# PIC32MX534/564/664/764

## PIC32MX534/564/664/764 Family Silicon Errata and Data Sheet Clarification

The PIC32MX534/564/664/764 family devices that you have received conform functionally to the current Device Data Sheet (DS60001156H), except for the anomalies described in this document.

FIGURE 1: EXTERNAL COMPARATOR SCHEMATIC EXAMPLE

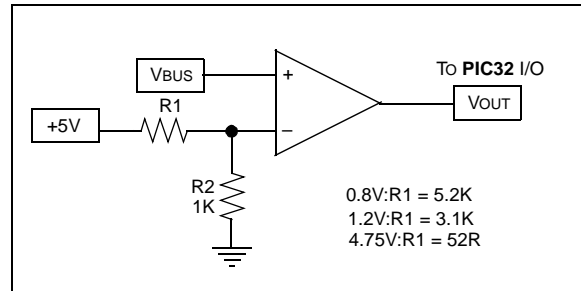
When the USB model is configured for OTG operation, it may not recognize all required OTG voltage levels on VBUS pin.

Use external comparator circuit to detect OTG specific voltage levels on VBUS pin.
